Your Ref:
Our Ref: B/LH021/DOC/20

[Lea Castle Farm, Wolverley, Worcestershire.
Proposed sand and gravel extraction, with progressive restoration – Hydrological
and Hydrogeological Assessment. Regulation 25 Request - Provision of additional
information with regard to consultee responses from the Environment Agency,
Natural England and Lead Local Flood Authority.](#)

Appendix 2 – Environment Agency Regional groundwater model data contour plot

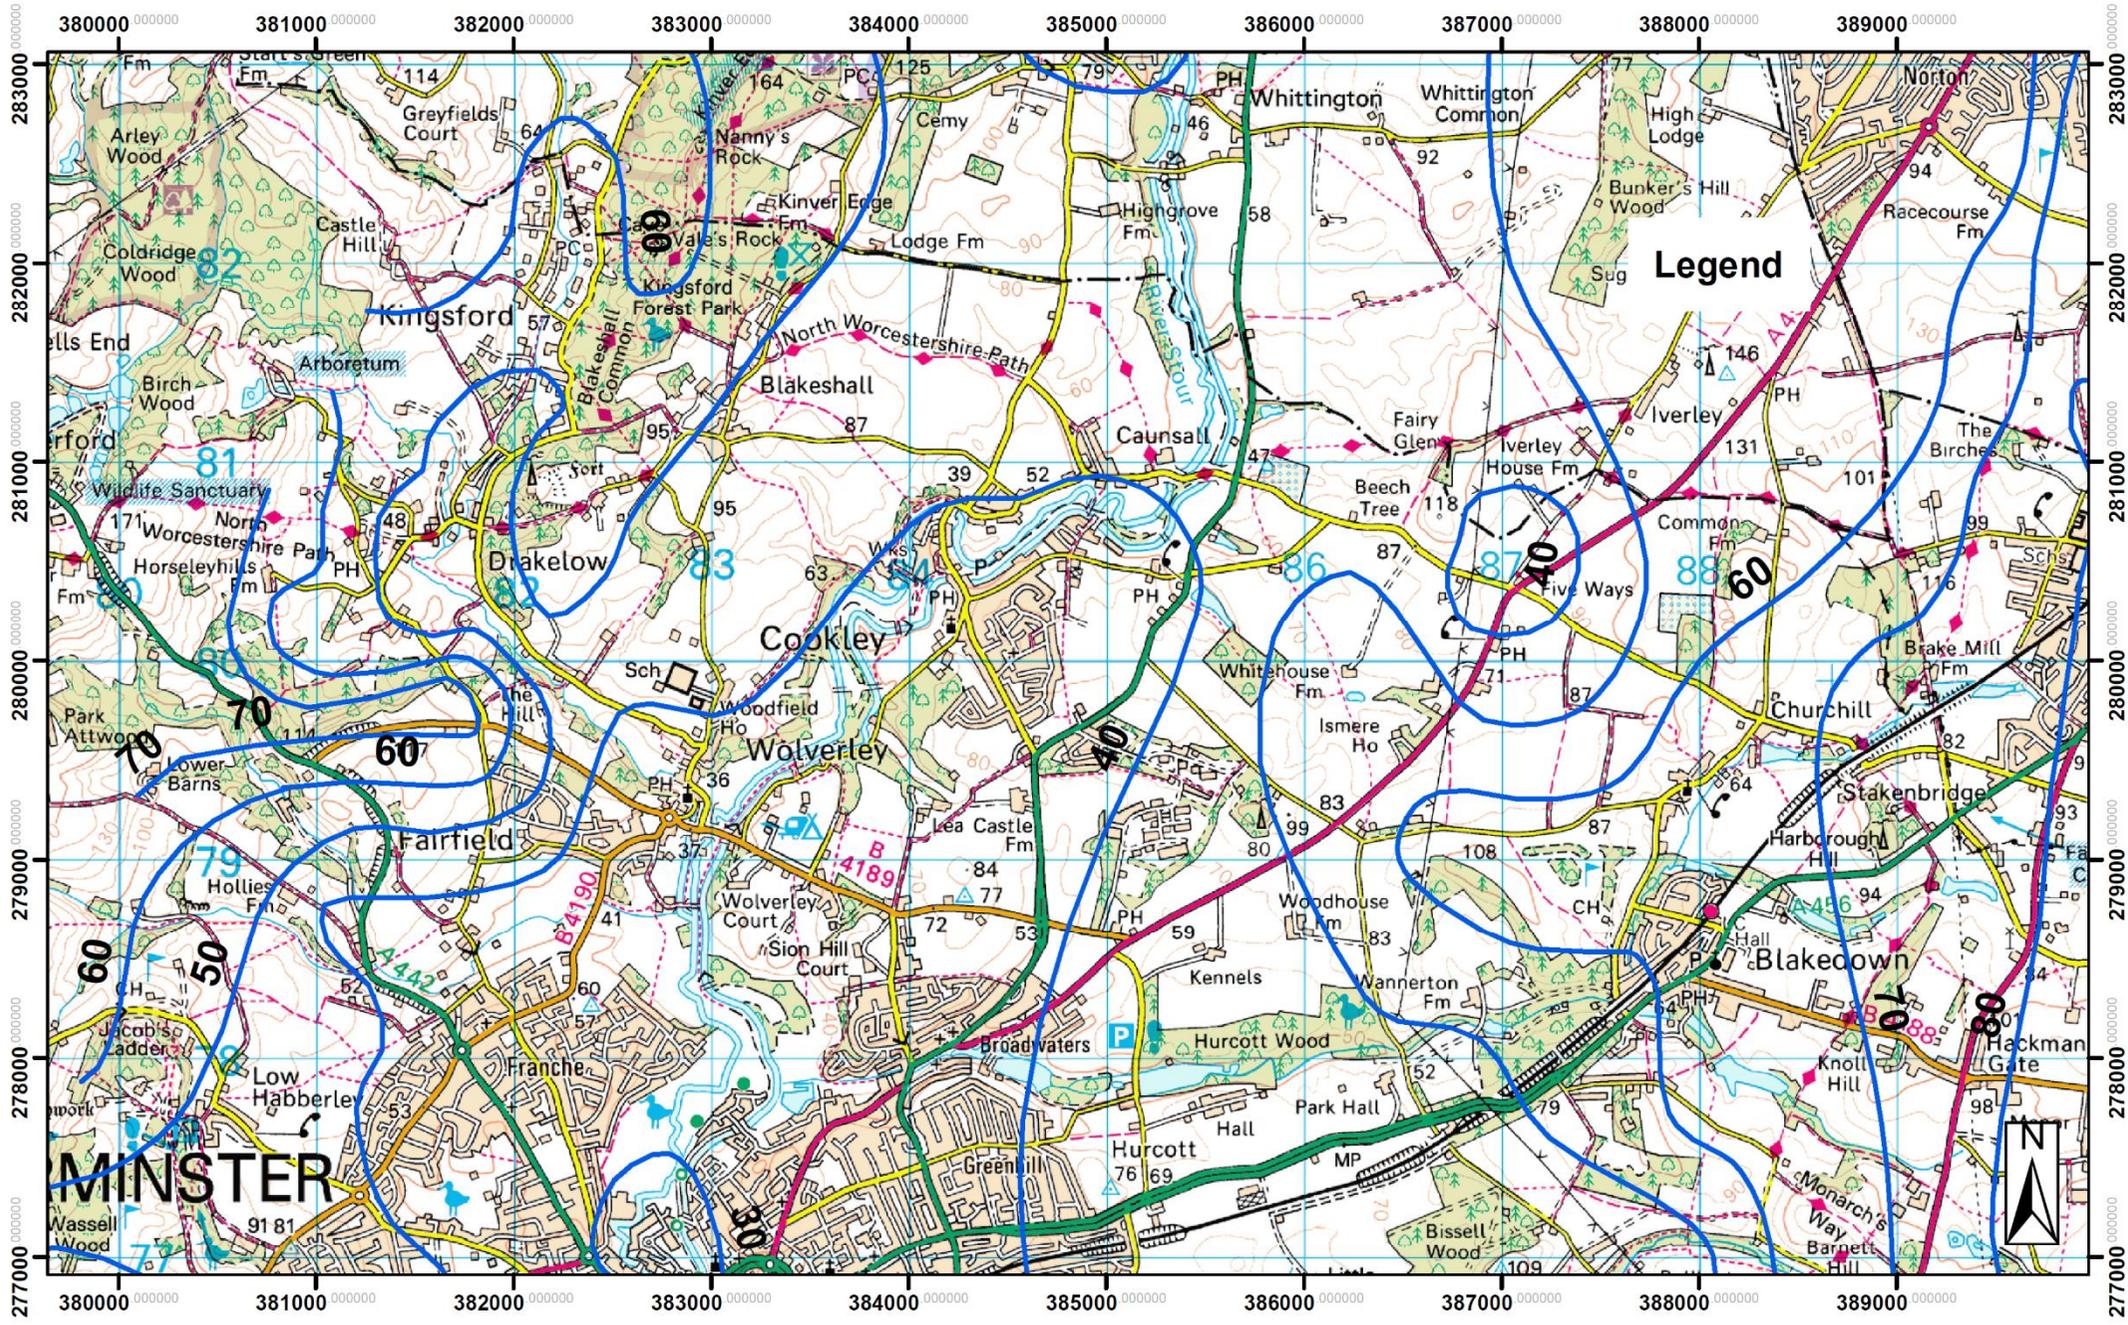
The hydrogeological data presented within our HHIA report draws on a wide range of data sources to allow definition of the conceptual model for the locality. The derived dataset suggests groundwater flow in proximity to the Site, is to the west/southwest and the River Stour. This expectation is confirmed by the regional groundwater flow dataset held by the EA, for which the output contour plot has been obtained and is now appended to this letter ([appendix 2](#)).

Both the Site derived and EA datasets indicate groundwater levels will reside at approximately 38maOD beneath the Site (EA dataset slightly lower). The EA have advised that the contour plot provided is expected to be indicative of 'average' groundwater elevation conditions for the locality and the regional flow pattern. This notwithstanding, the Ordnance Survey mapping data for the valley to the south of the Site (in proximity to the Hurcott and Podmore Pool SSSI and Hurcott Pasture SSSI) indicates an elevation of some 42maOD within the valley i.e. above the groundwater level expected at the Site. On this basis, groundwater beneath the Site is located down hydraulic gradient of the protected areas and hence will not be contributing to flows through the aforementioned protected sites.

PROJECT:	
Lea Castle Farm	
TITLE:	
Concept Restoration	
REF NO:	
KD,LCF,031	
DATE:	SCALE:
September 2020	1:5,000 @ A3
STATUS:	
FINAL

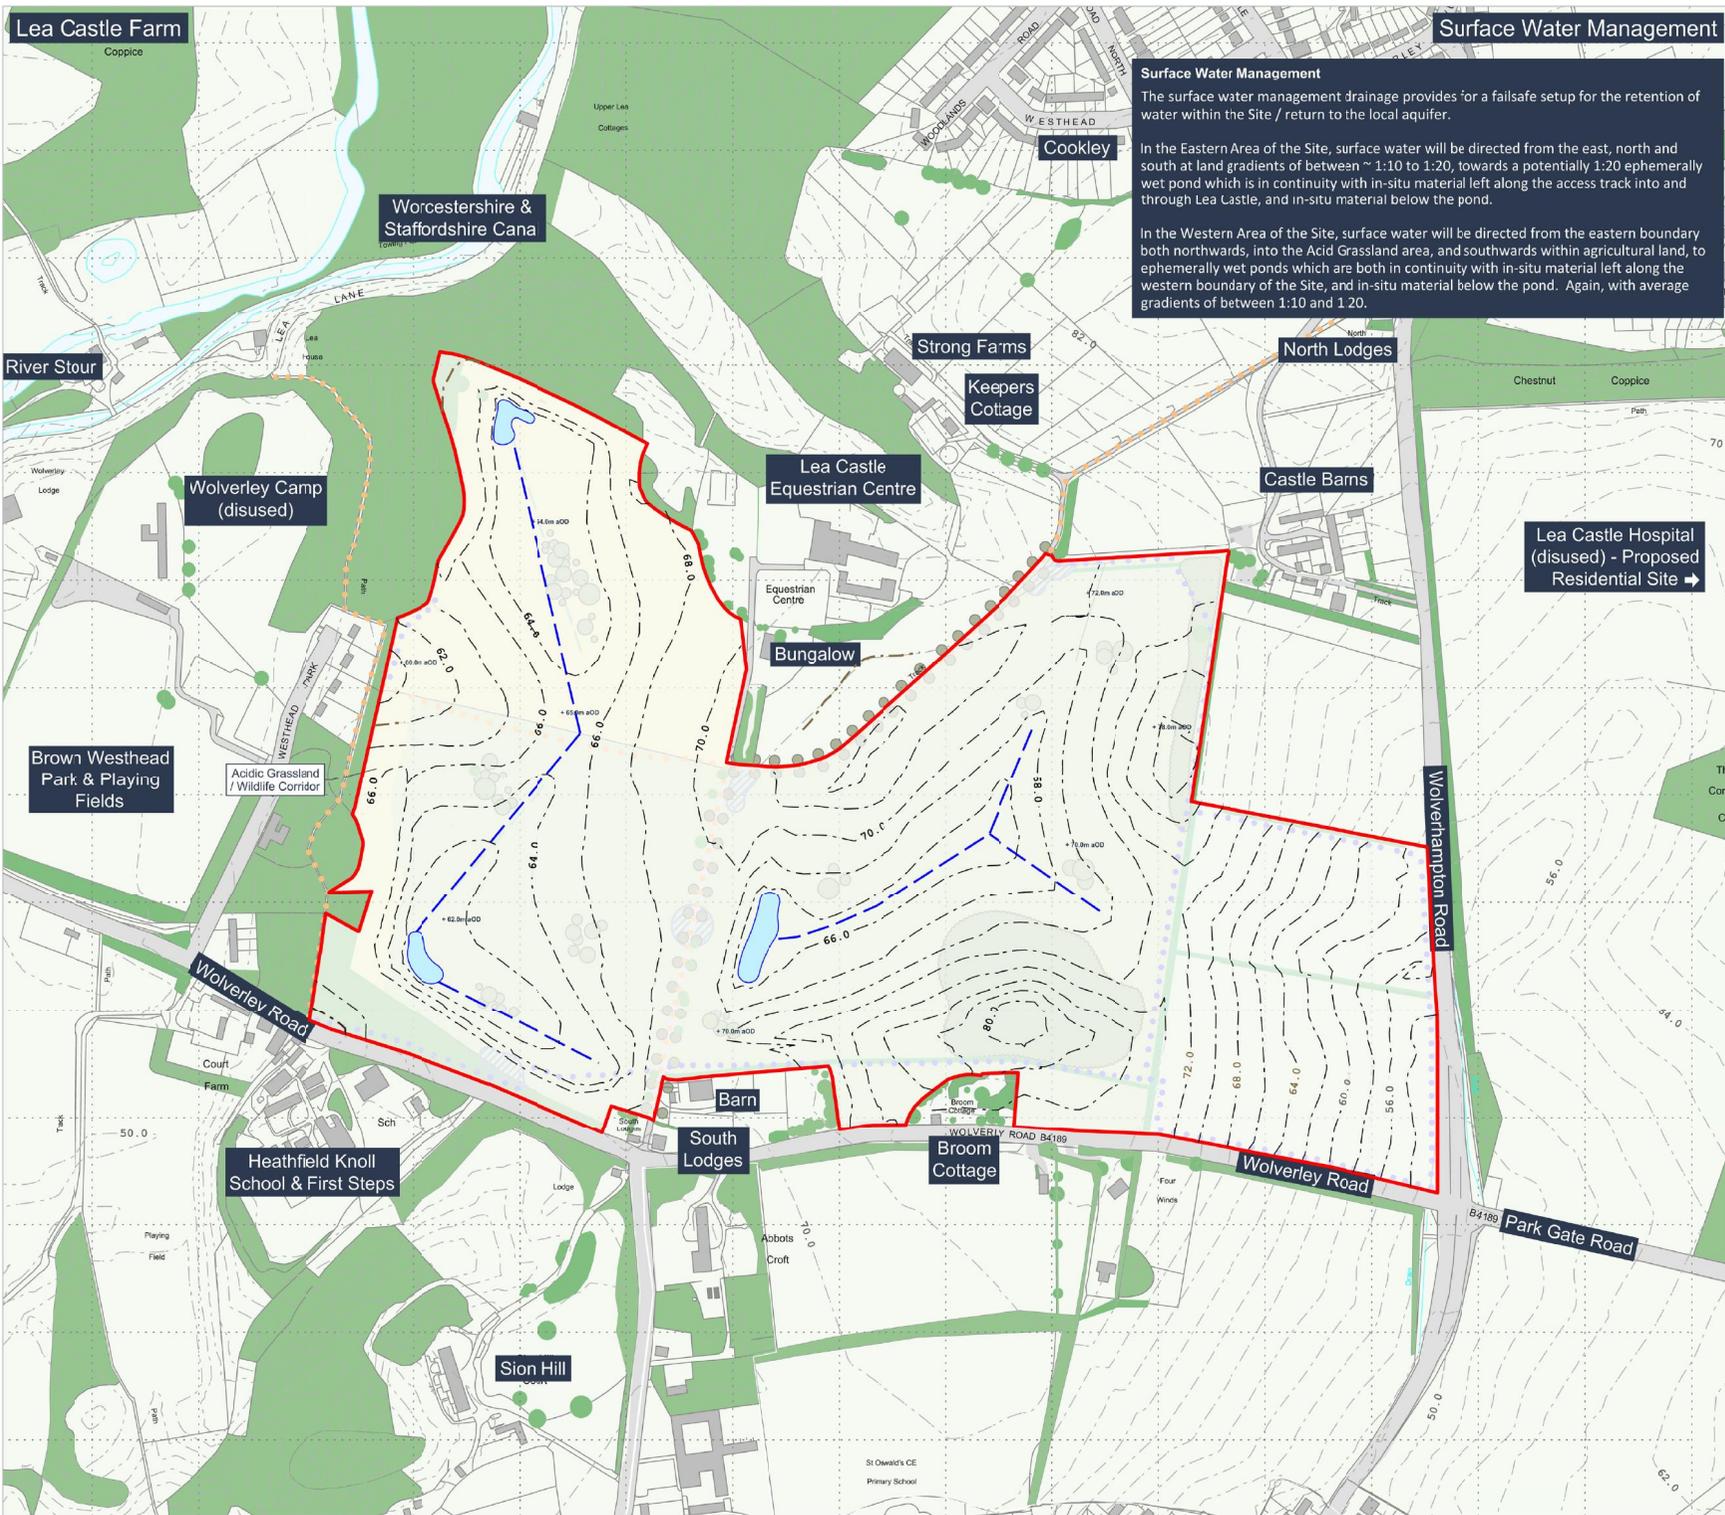
Following submission of the planning application, the restoration landform has been amended to maximise the ecological benefit offered by the restored Site (**appendix 3** – drawing KD.LCF.031). This has included enlargement of the aforementioned soakaway areas and refinement of the contributing

catchment drainage. Each area is located within a gentle bowl feature, enclosed by an approximate 2m high rise in ground elevation to the western boundary (the lowest elevation flank).
